Town of Arlington, MA Redevelopment Board

Agenda & Meeting Notice January 13, 2025

4. Public Hearing: Docket #3821, 1513-1515 and 1517-1519 Massachusetts Avenue (continued from December 2, 2024)

Please be advised that we represent the Applicant, IG Investments LLC, in connection with Special Permit, Docket #3821, for properties located at 1513-1515 and 1517-1519 Massachusetts Ave, Arlington, Massachusetts. Based upon our last hearing before your Board on December 2, 2024, several modifications have been made to the proposed project which are reflected on the plans and submission materials. Please find included a summary of Board comments and the Development Team's responses as well as specific updates to materials including:

ELEVATIONS

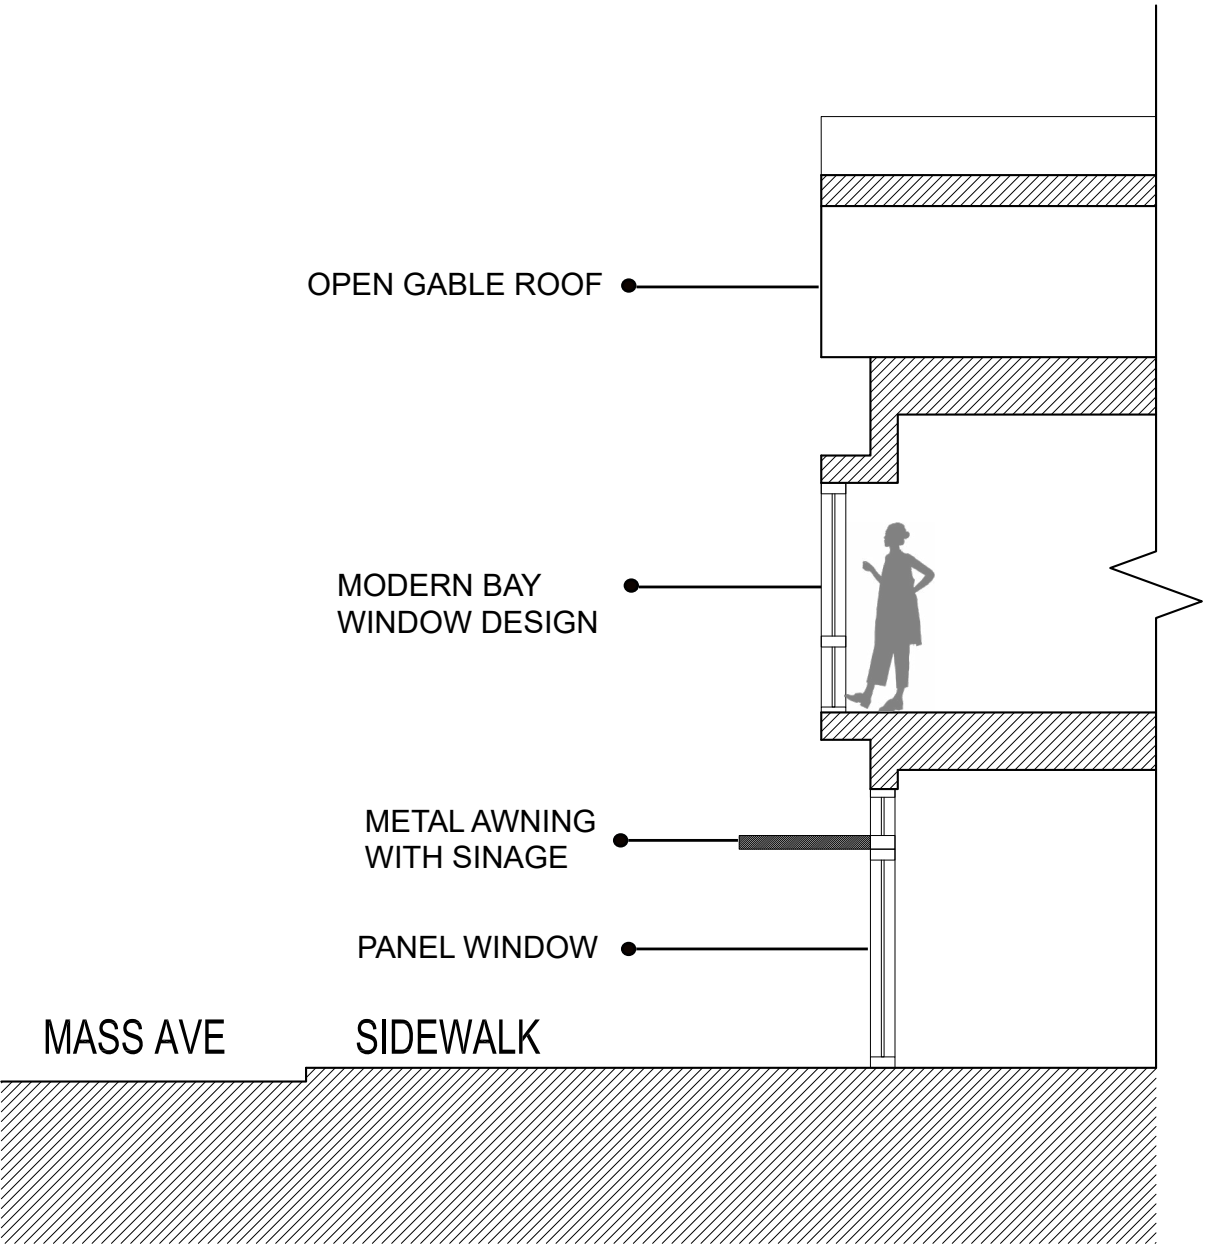
Consider the openings to the parking area on the rear and left side of the building and include trim and detail to correctly show the opening.

- Revisions have been made to the trim to denote a separation between the first and second floor and correctly show the opening.
